The Town of Hilton Head Island Regular Design Review Board Meeting

Tuesday, March 8, 2011

REVISED AGENDA

DESIGN TEAM/ DRB COMMENT SHEET

RAILING DETAIL 1"=1'-0"

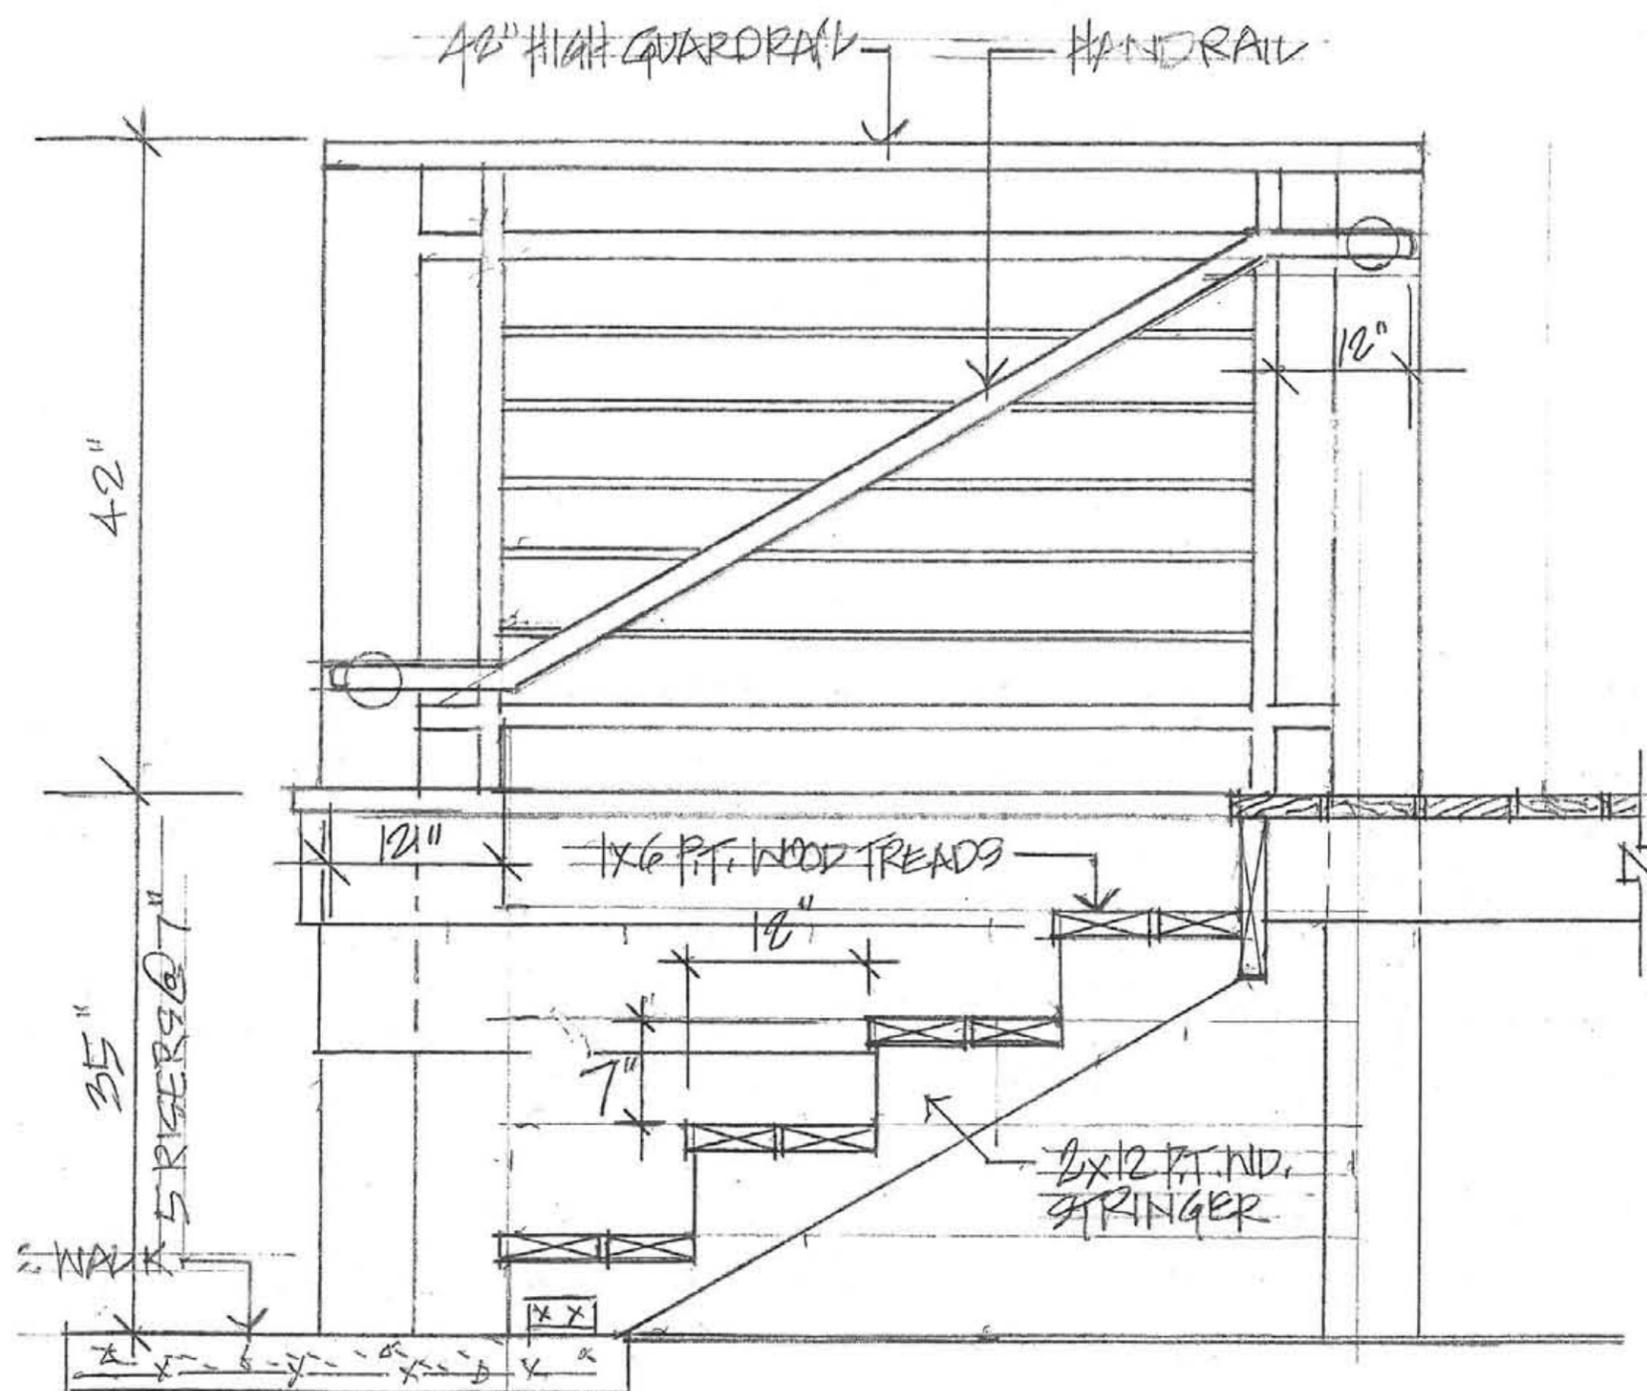
ARCHITECTURAL DESIGN
Railing detail incorporates the improvements proposed by the board. Top rail should probably have a larger dimension than the post. Finishes (stain, paint, etc.) should be clarified. Landscape material should be identified (Viburnum, Indian Hawthorn, etc.)

AWNING STRUCTURE

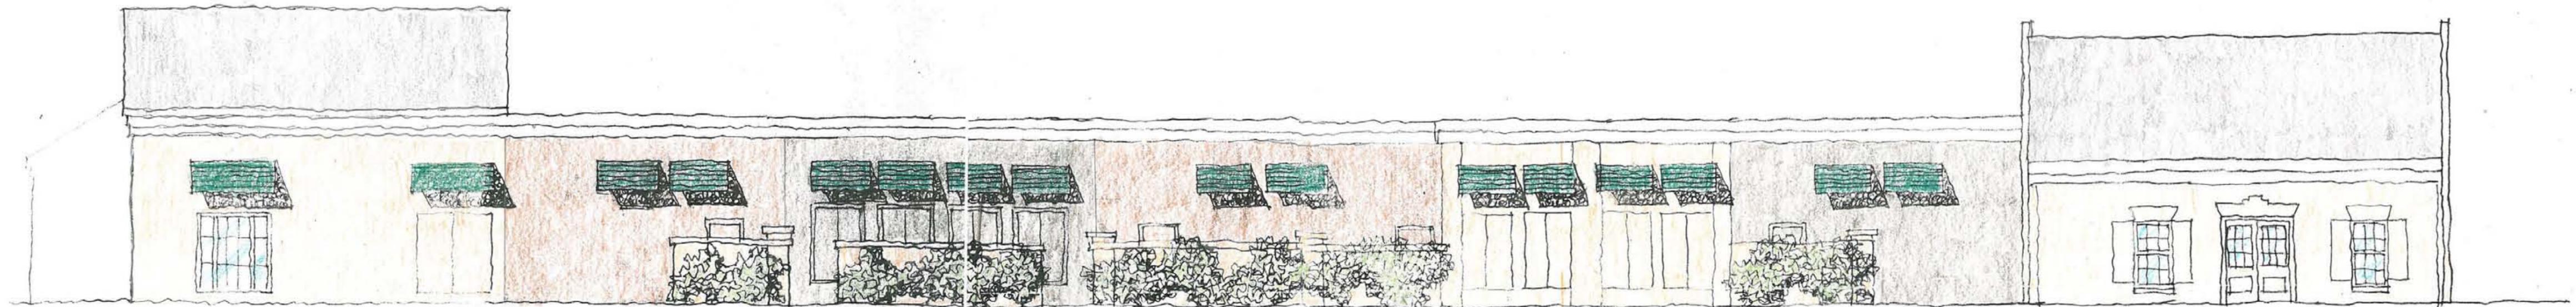
1. Detail of screen wall needs to be clarified (its assumed it matched the existing)
2. Proposed Landscaping needs to be clarified
3. Paint palette provides variety and interest to the elevation, but does it tie into the existing color of the end walls on the end units. A paint key should be provided to clarify the applications. Paint colors will be provided at the meeting. Scan quality doesn't represent actual samples.

2 FLOOR PLAN
A 4" = 1'-0"

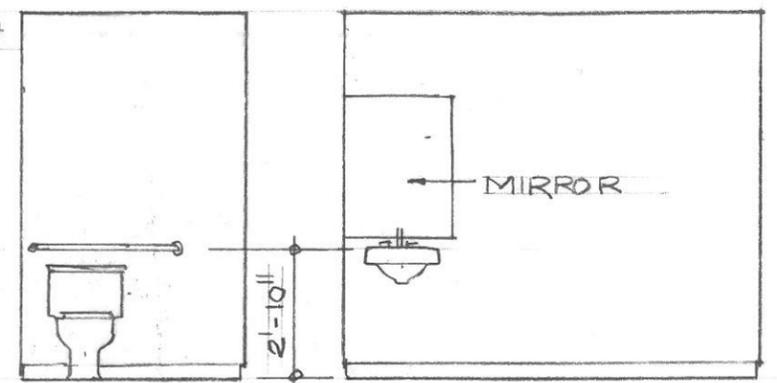
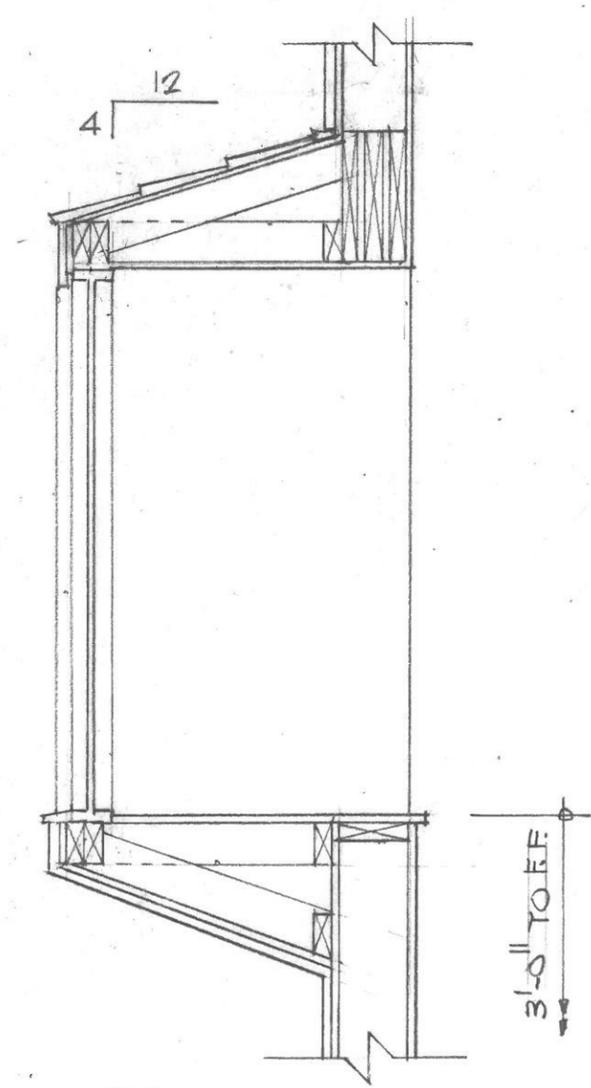
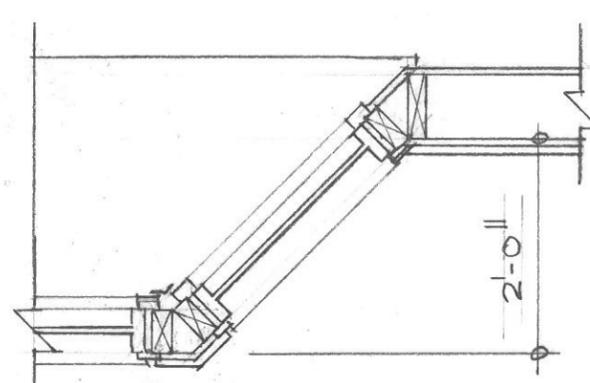
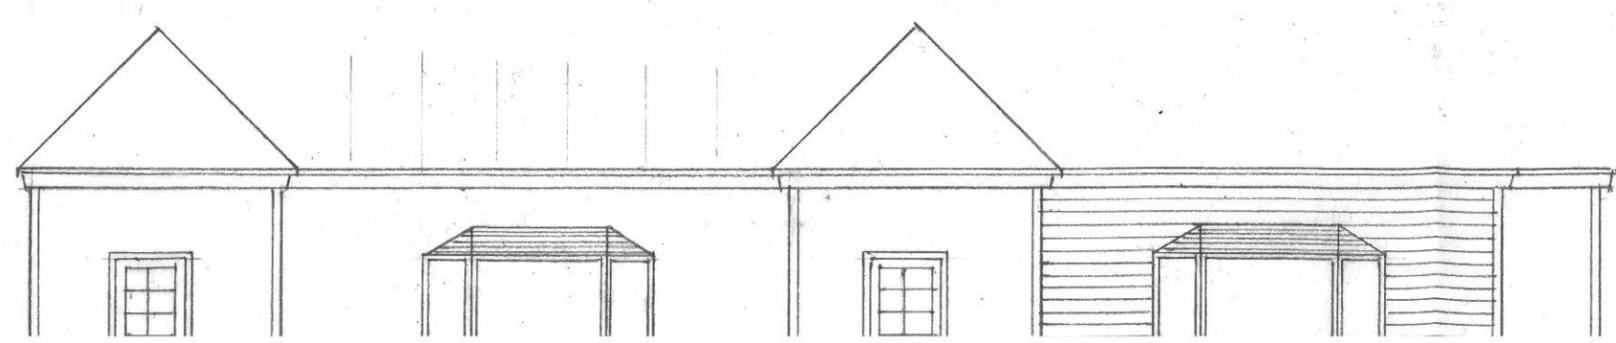
ARCHITECTURAL DESIGN		
Change in fenestration feels slightly under-proportioned, and if bays are installed they should be in keeping with the facades.		
DESIGN GUIDE/LMO CRITERIA	COMPLIES YES/NO/N/A	COMMENTS OR CONDITIONS
Structure is designed to be appropriate to the neighborhood		
Promotes pedestrian scale and circulation		
Design is unobtrusive and set into the natural environment		
Utilizes natural materials and colors		
Avoids distinctive vernacular styles		
Design is appropriate for its use		
All facades are have equal design characteristics		
Avoids monotonous planes or unrelieved repetition		
Has a strong roof form with enough variety to provide visual interest		
Minimum roof pitch of 6/12		
Overhangs are sufficient for the façade height.		
Forms an details are sufficient to reduce the mass of the structure		
Human scale is achieved by the use of proper proportions and architectural elements		
Utilizes a variety of materials, textures and colors

PROJECT NO. 10-039
 DATE 07/07/11
 DRAWN BY
 CHECKED BY
 SHEET NO. A3.0
 EXTERIOR ELEVATION

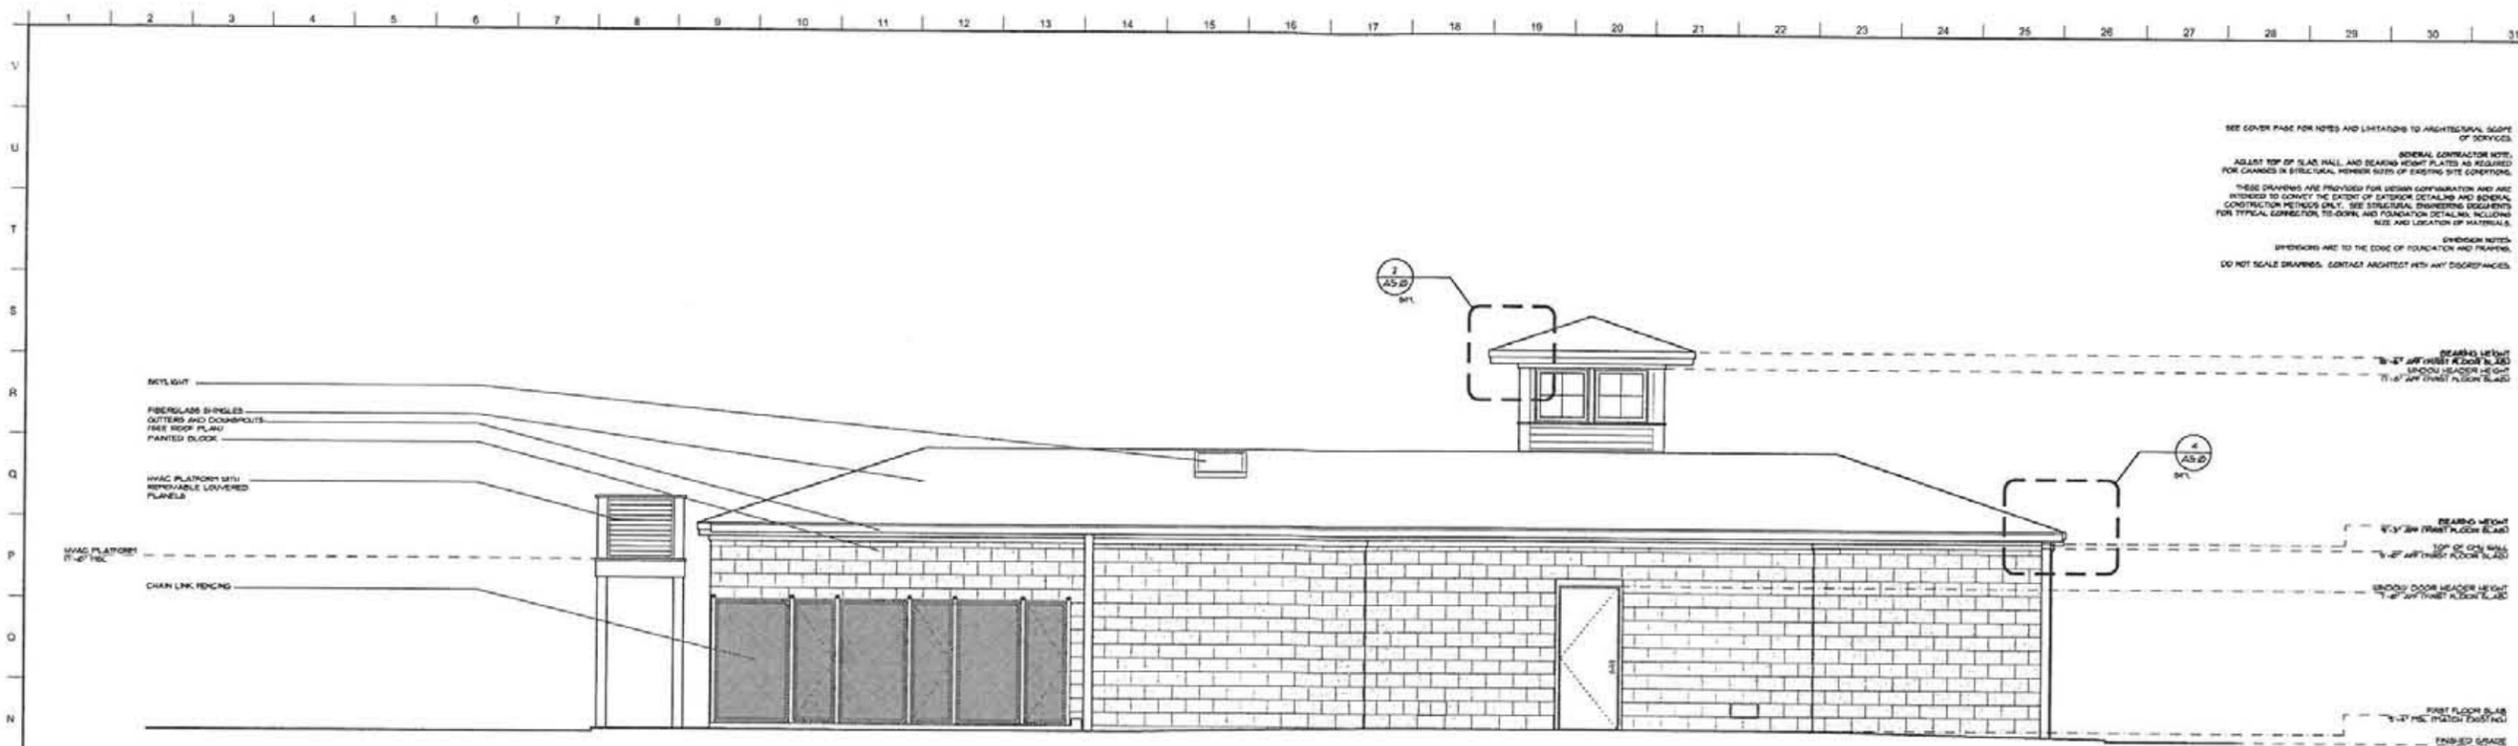
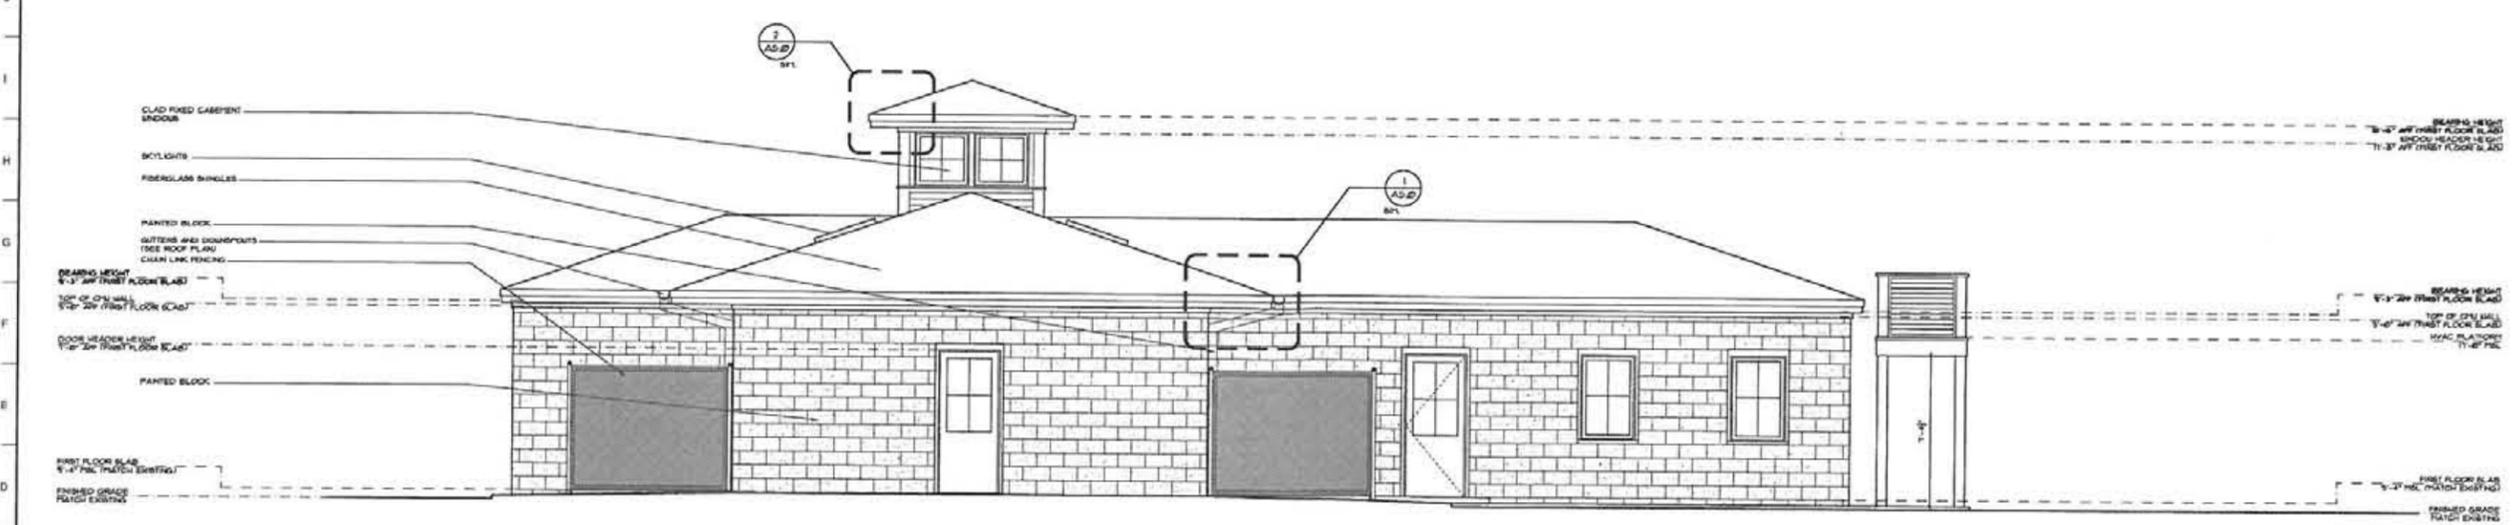
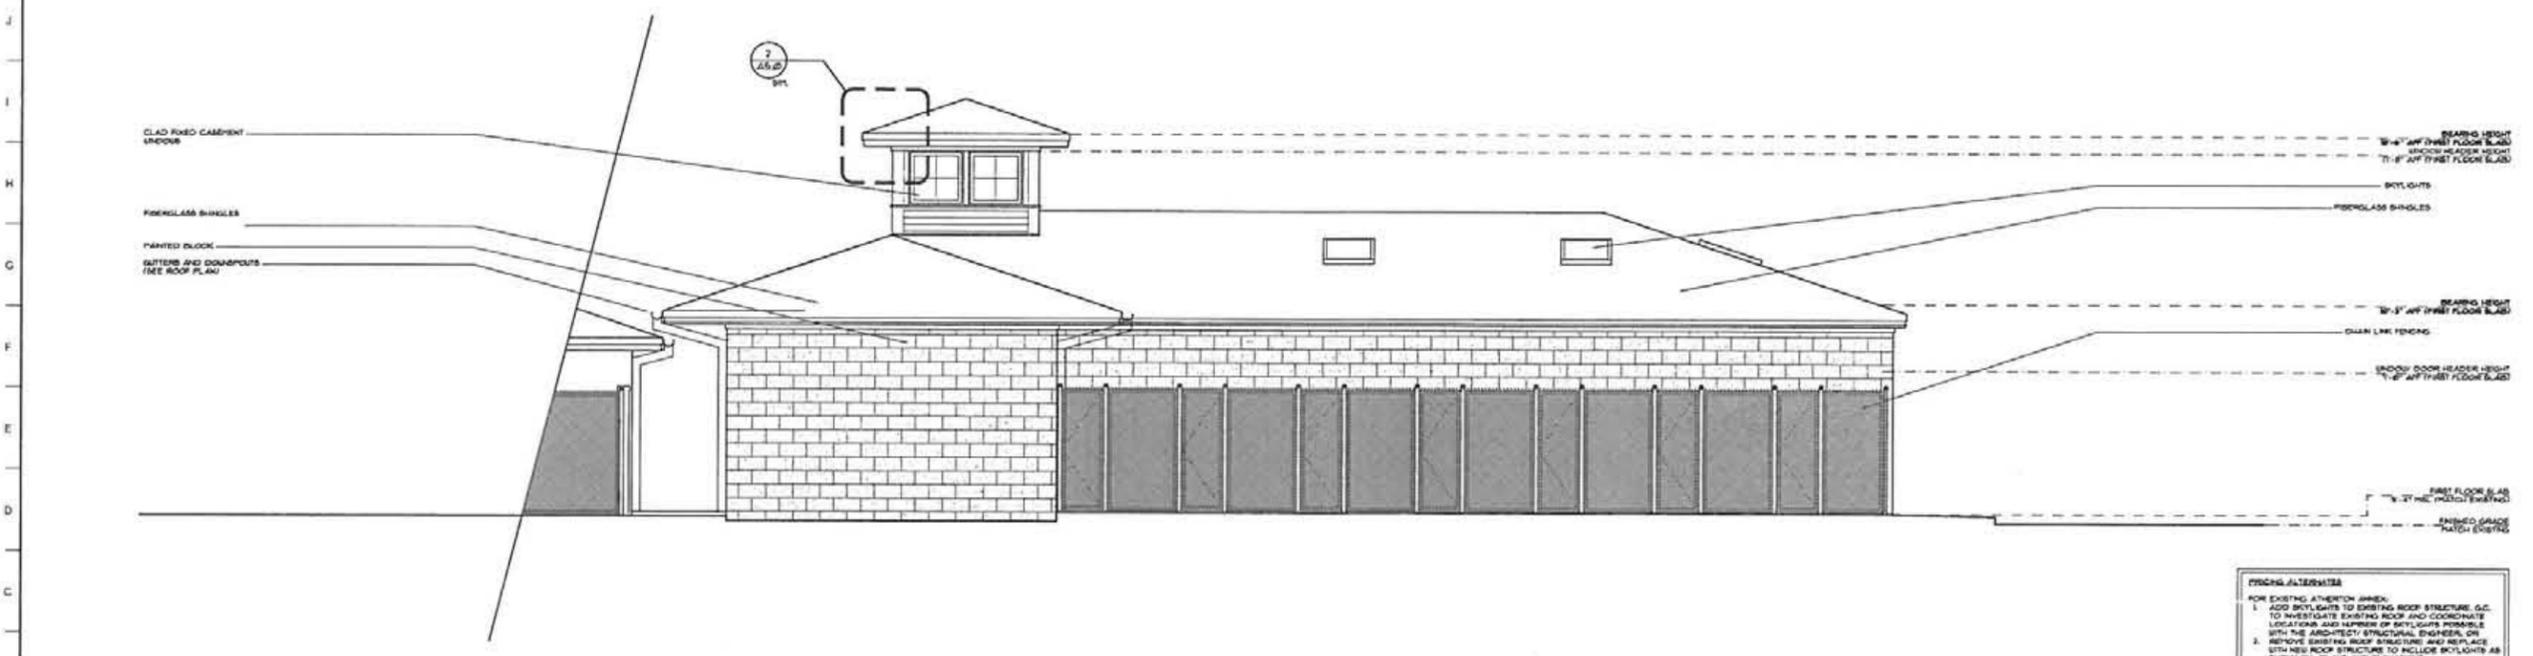
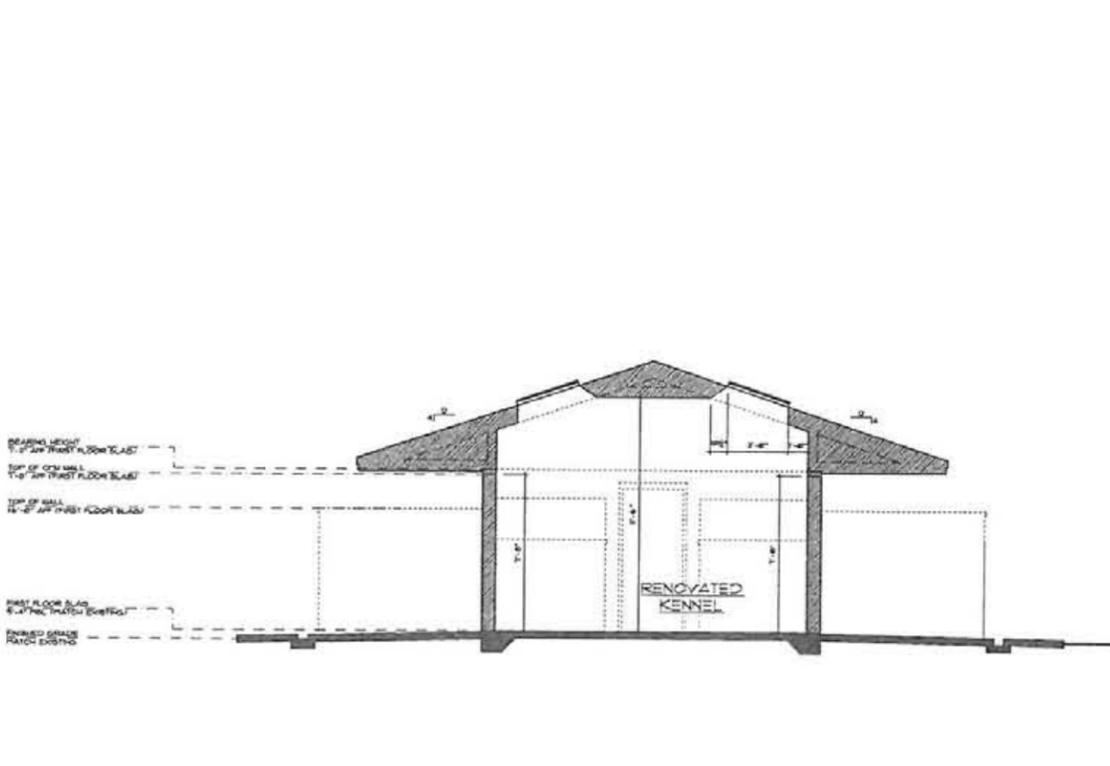
Renovation and addition are in keeping with the first phase of improvements at the Humane Association. Hardi-plank honors public areas. There are functional and visibility issues to consider when reviewing the CMU elevations relative to typical applications. Color samples will be provided at the meeting.
